Technical Service Information

MAZDA RA4A-EL NISSAN RE4R03A

LOCK-UP SHUDDER (2 LOCK-UP SOLENOID UNITS ONLY)

Figure 1

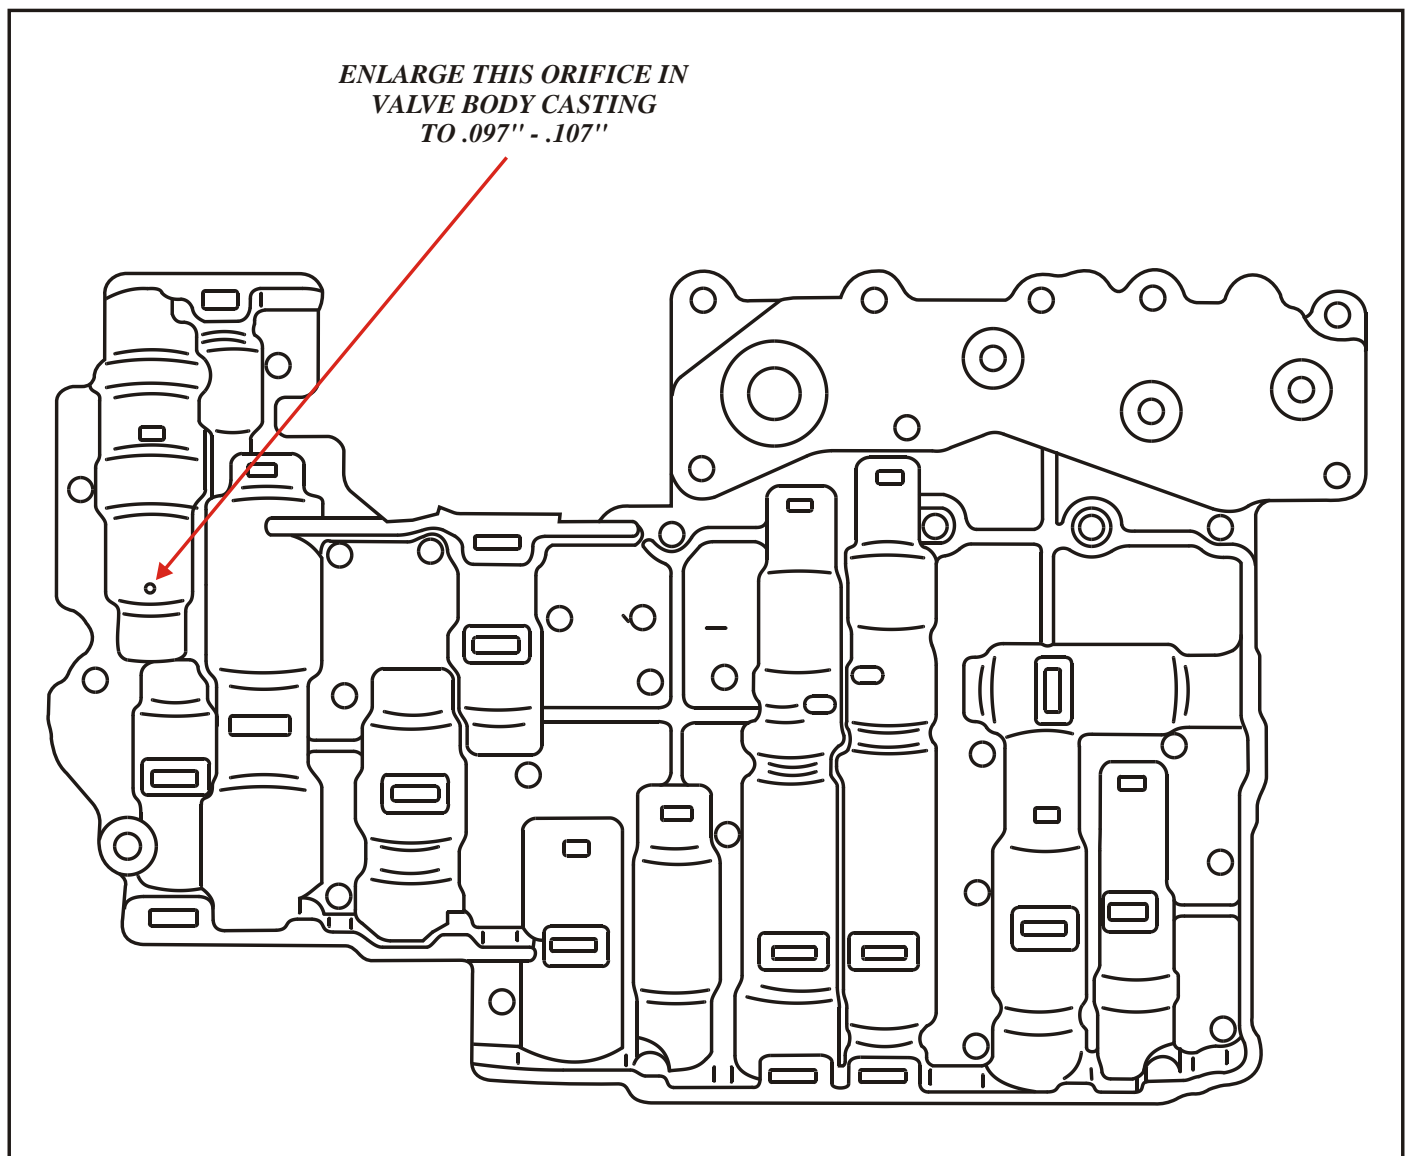
COMPLAINT: Some Mazda or Nissan vehicles equipped with the RA4AEL or RE4R03A may exhibit a lock-up shutter upon application of the lock-up clutch.

CAUSE: One cause may be lock-up release oil not exhausting quickly enough through the lock-up control valve.

CORRECTION: Drill hole and open orifice in the bottom of the valve-body as shown in Figure 1 below.
